GRANGER PARK – WATER QUALITY POND STORMWATER IMPROVEMENT PROJECT

CITY OF LAGRANGE

ADDENDUM NO. 3: REVISIONS AND PRE-BID MEETING MINUTES

MARCH 3, 2017

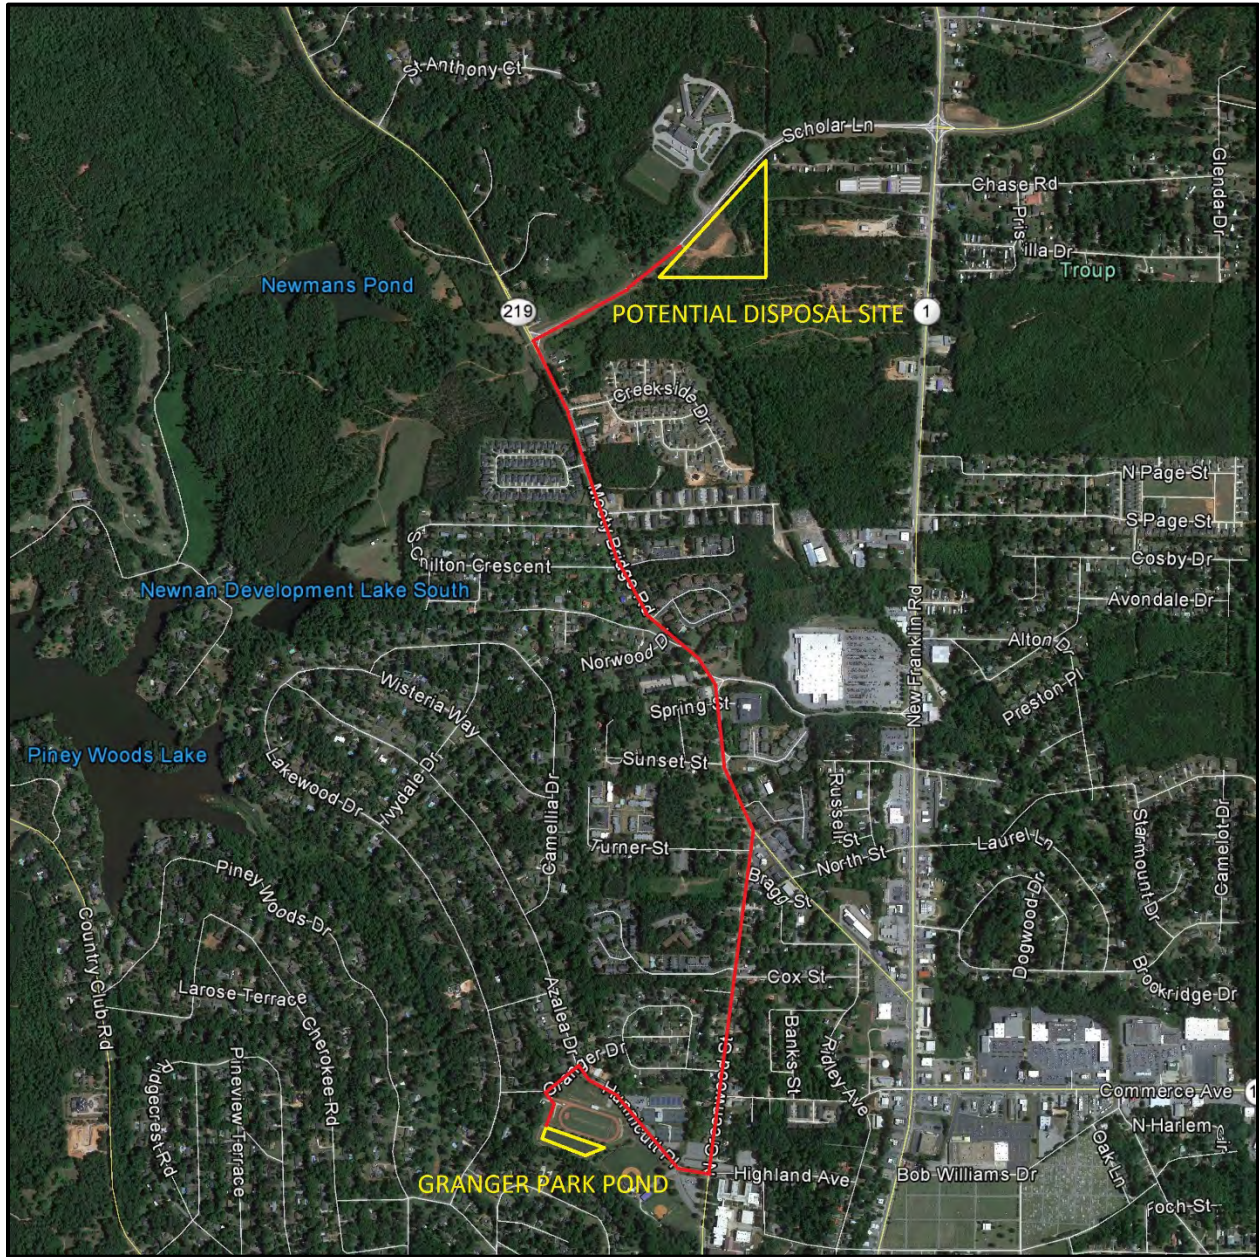
- Potential non-landfill disposal site: open lot south of Franklin Forest Elementary School, approximately 2.5 miles from Granger Park (See attached).
- Future Thread Trail construction concurrent with this project.
- Time for performance is 90 Consecutive Calendar Days from Notice to Proceed to complete the project.
- Insurance Requirements: Please see the contract documents for Insurance Requirements.
- Immigration Compliance: Please see the contract documents for Immigration Compliance.
- Warranty: The Contractor shall warrant all work performed under the Contract for a period of one (1) year from the date of acceptance of the Project by the City.
- Traffic Control.
- Site Conditions: Public park, Stormwater, Erosion, Dewatering.
- Bidders to acknowledge receipt of all addenda via email to RMA.

- City Landfill will accept dredged material and no disposal fee is required.
- The "Potential Disposal Site" shown on the attached aerial image has already been secured for disposing of dredged material. As with any non-landfill site, this site will require additional erosion control measures and NPDES permitting.

- The "Potential Disposal Site" would require minimal clearing, if any, and has a suitable ground slope for draining dredged material.
- The Thread Trail construction project has been awarded. The plans will be provided to prospective bidders.

9 **SMWA # 2**
CL7.7 **OUTLET CONTROL STRUCTURE DETAIL**
SCALE: 1/2" = 1'-0"

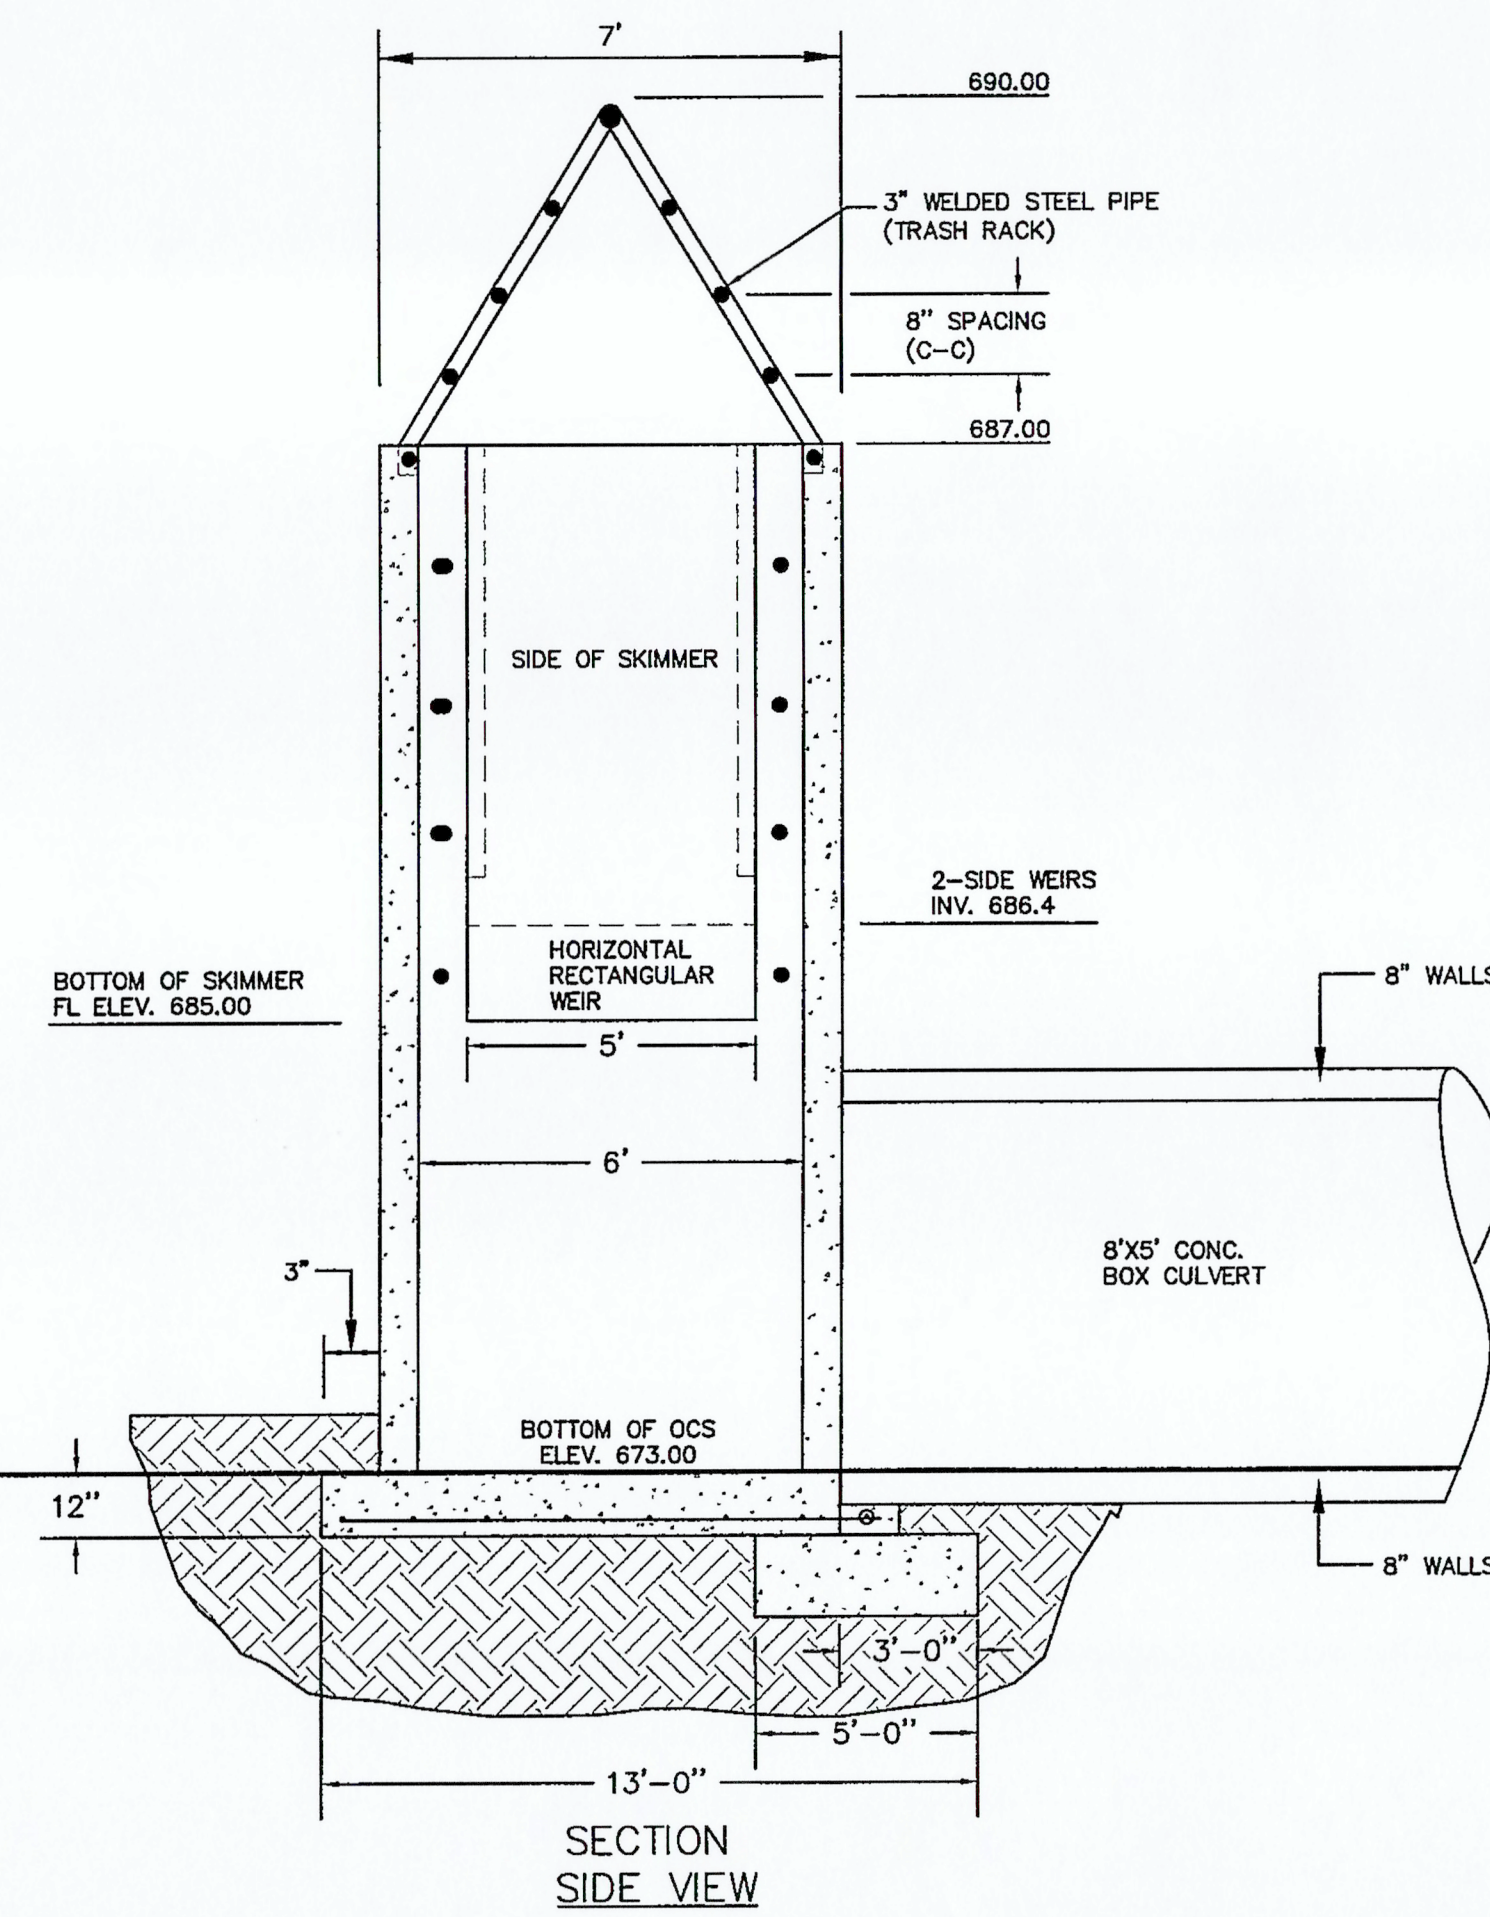
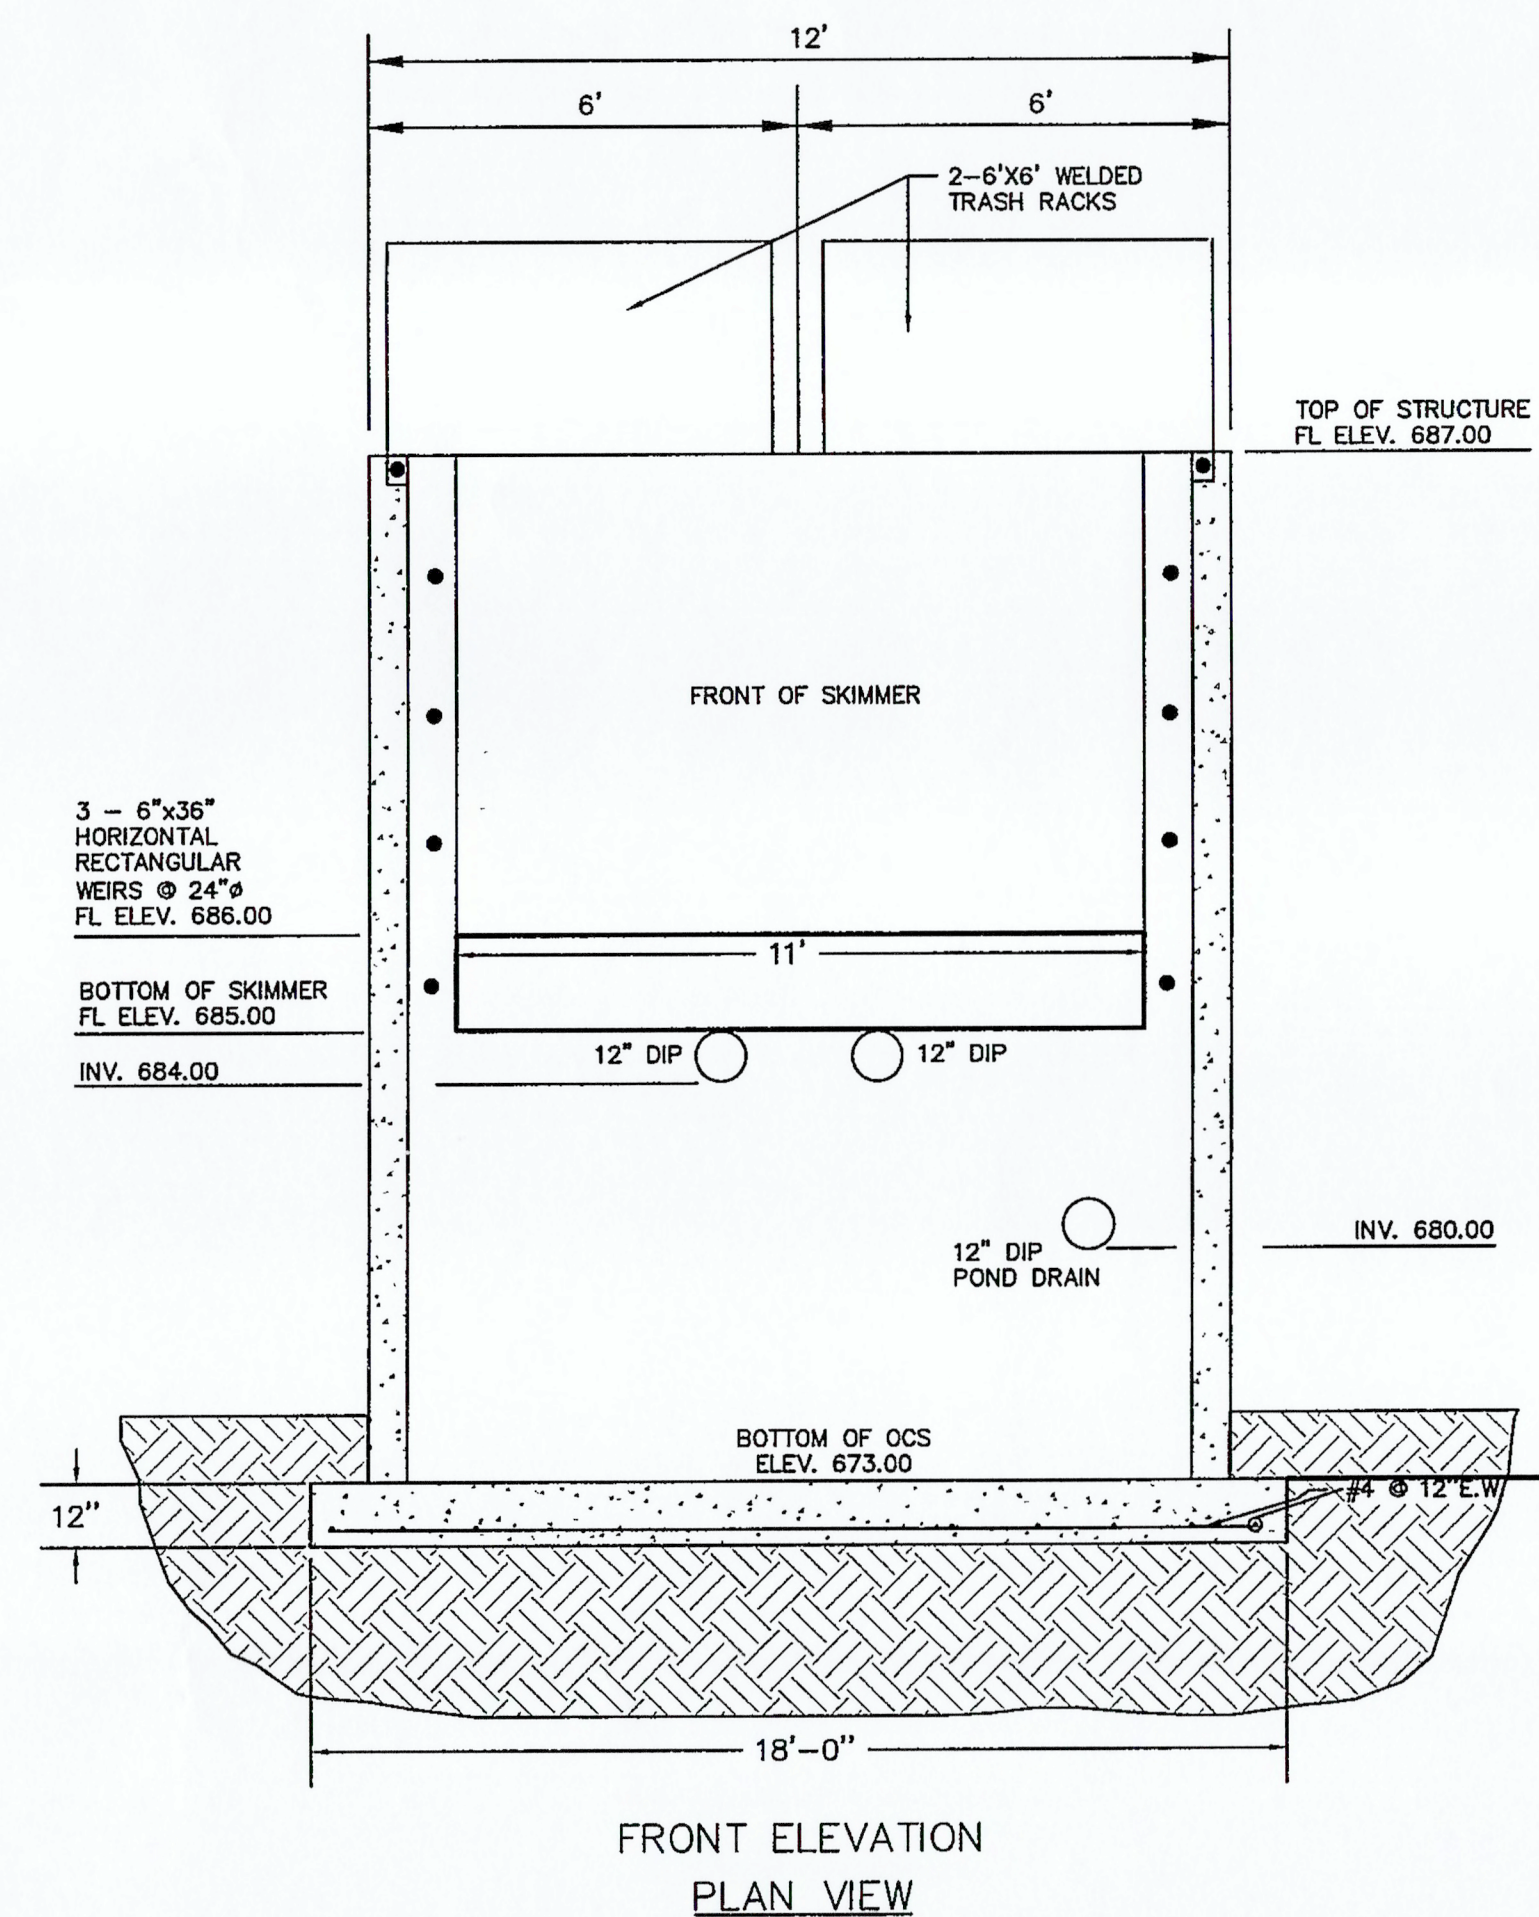
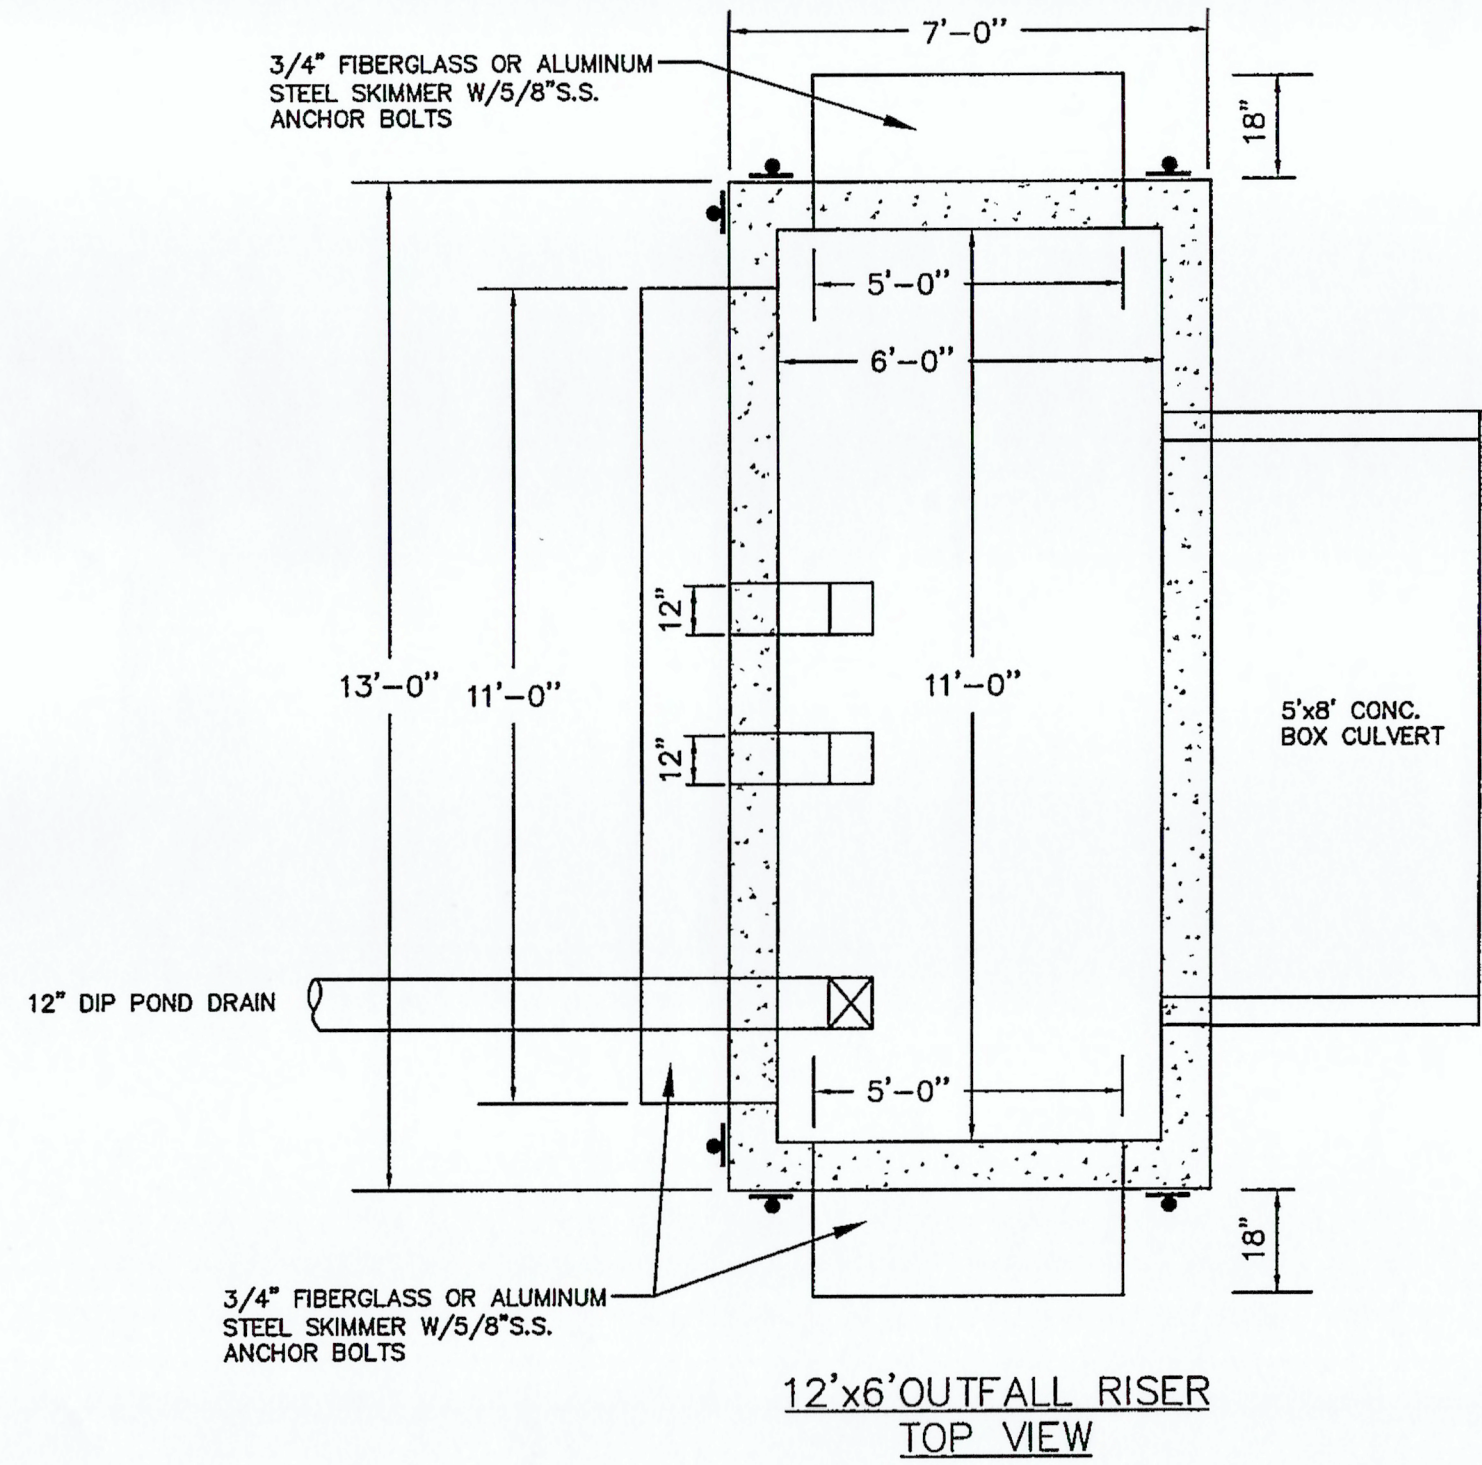
- Typical volume of water in pond is approximately 210,000 CF (1.6 MG).
- Details of the existing outlet control structure from the original pond design drawings (not as-builts) are attached.
